RADFORD ARMY AMMUNITION PLANT, VIRGINIA

Work Plan Addendum 012: Site Characterization Plan for

**SWMU 39
SWMU 48
SWMU 49
SWMU 50
SWMU 58
SWMU 59
AOC-FLFA
AOC-Building 4343
New River Unit**

Re: Radford Army Ammunition Plant
SWMUs 39, 48, 49, 50, 58, and 59
Former Lead Furnace AOC and Building 4343 AOC
New River Units
Work Plan Addendum 12
Document submittal and review

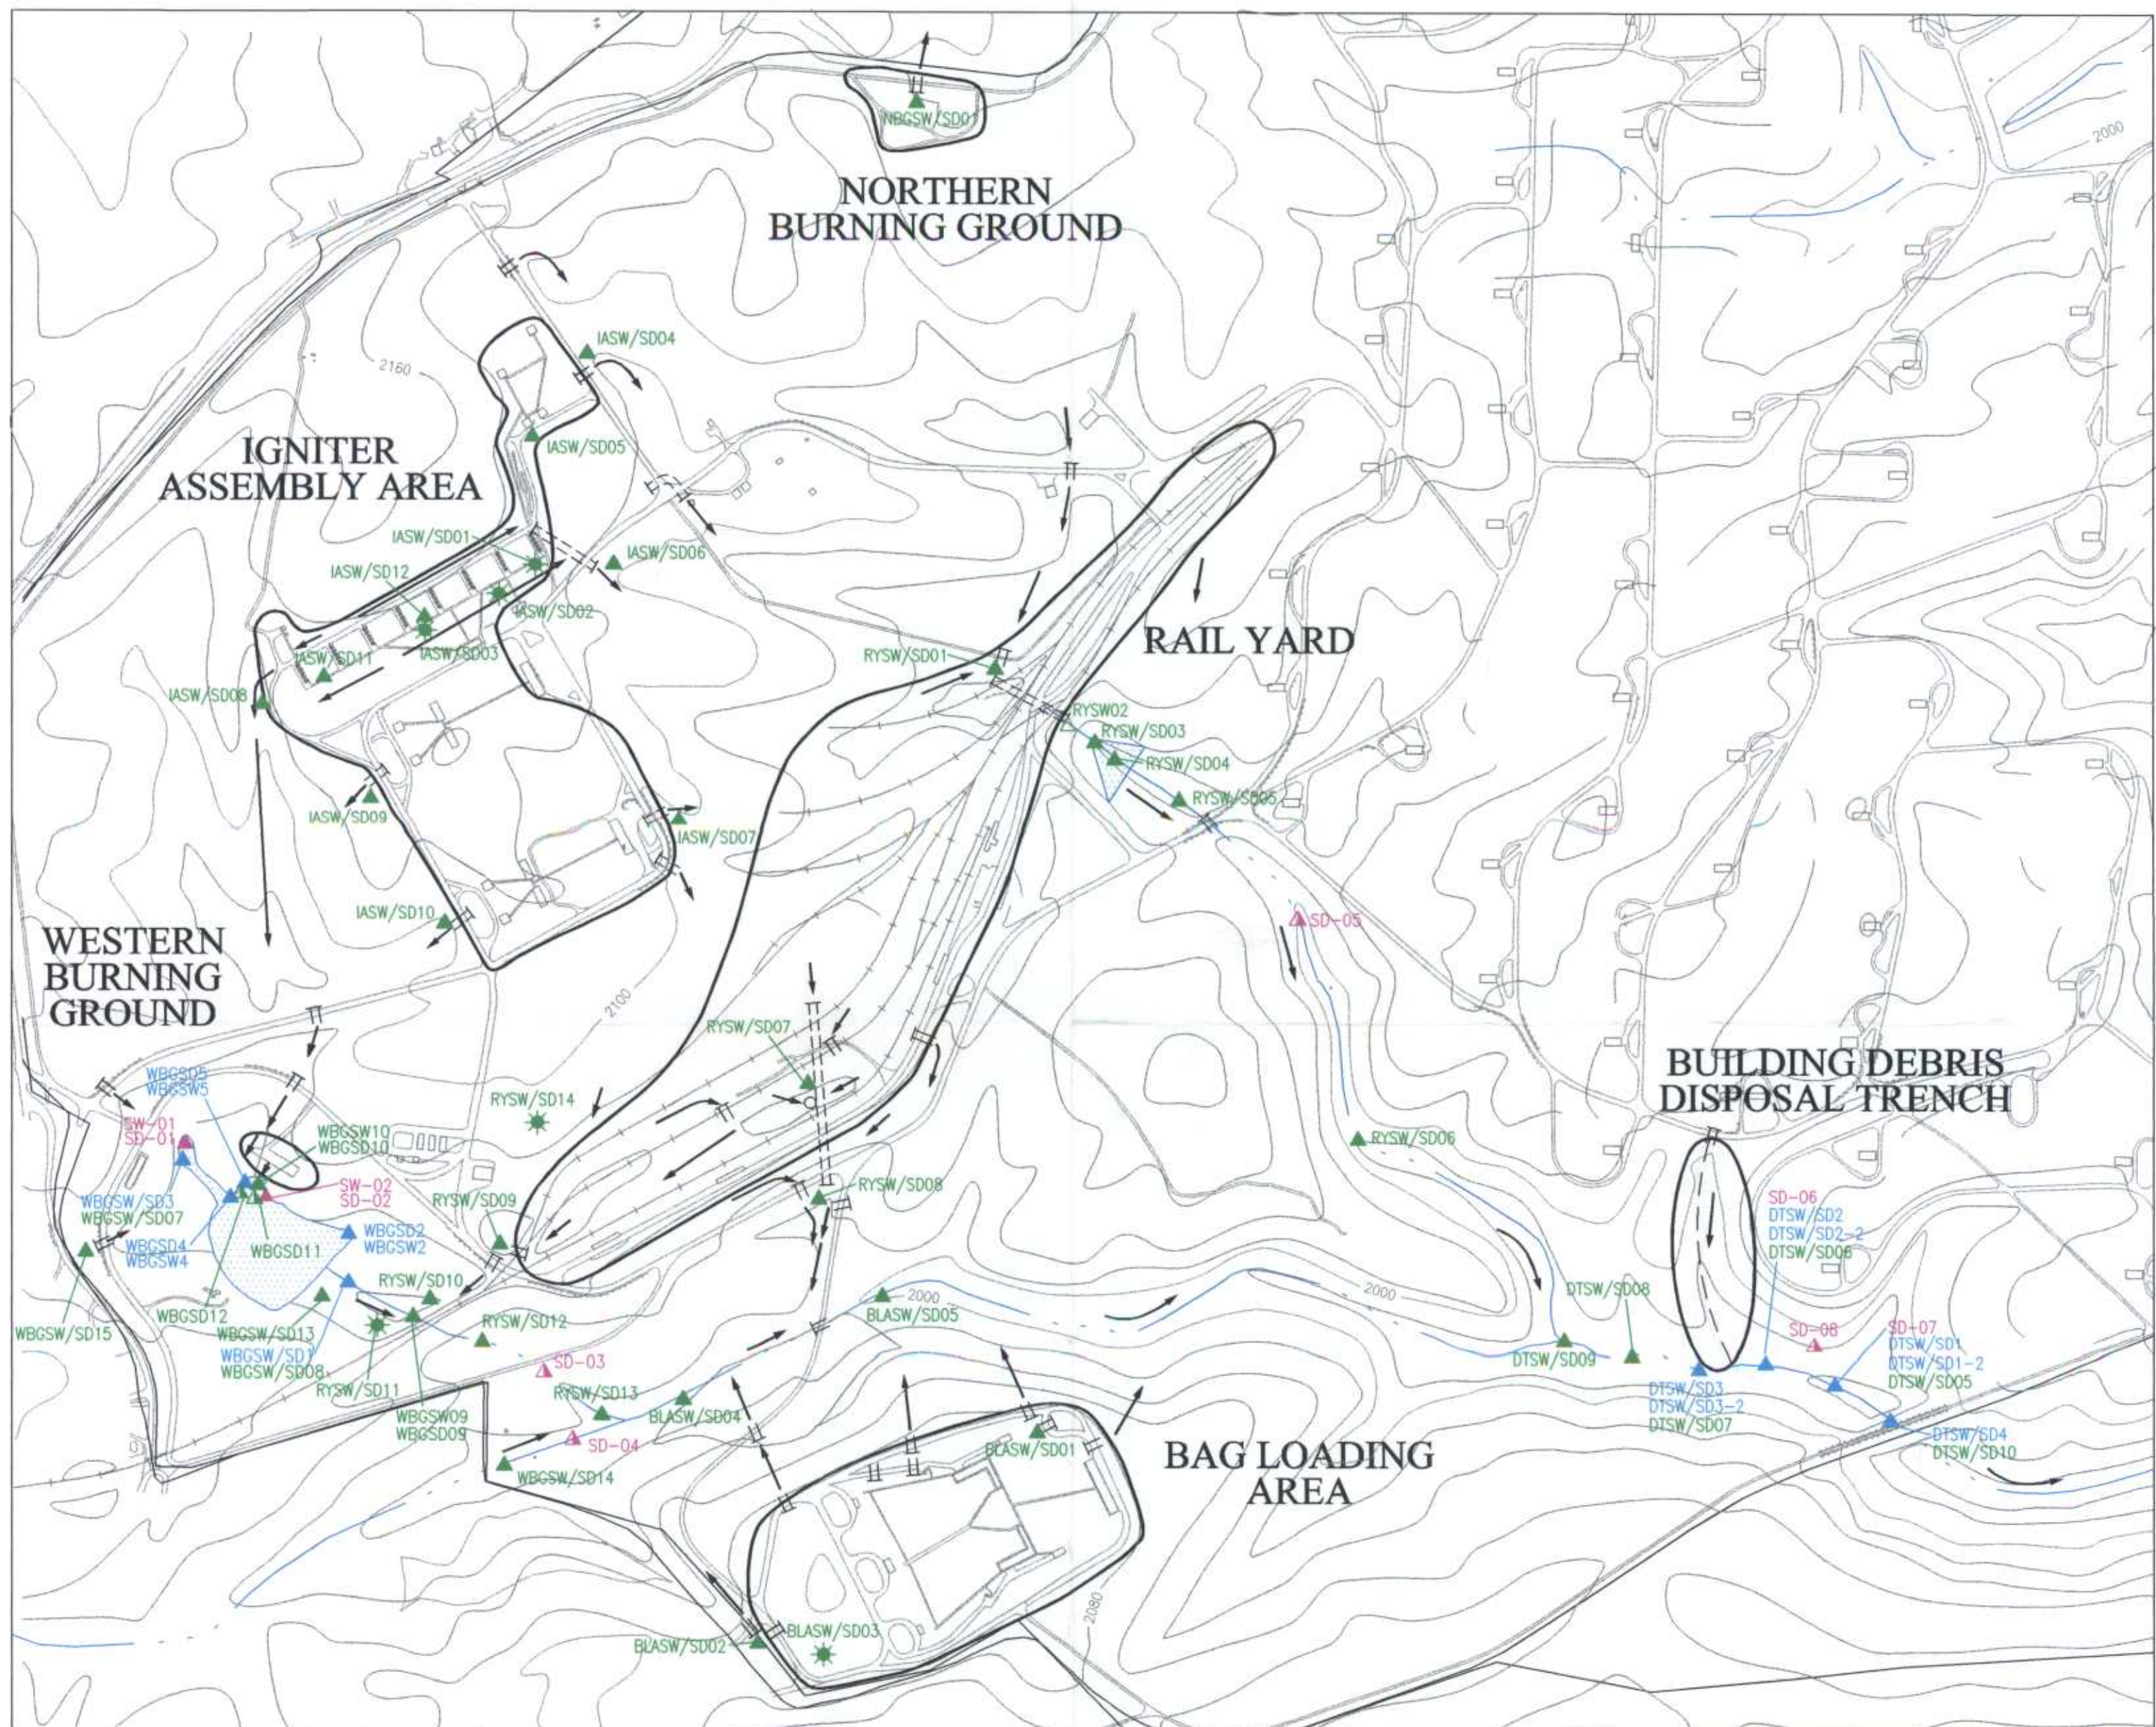
Comment: Figure 1.14-1 does not indicate the location of the second soil sample taken in 1997 by Gannett Fleming. Please mark the site, as it is the sample showing the most contamination.

2. Figure 1.14-1 does not indicate the location of the second soil sample taken in 1997 by Gannett Fleming. Please mark the site, as it is the sample showing the most contamination.

Response: The second soil sample (SS-08) collected in 1997 by Gannett Fleming was present on Figure 1.14-1, but was colored incorrectly on the figure. For consistency purposes, site figures have been color coded to designate samples collected by a specific contractor versus a different color for each investigation. Color coding designations were assigned as follows:
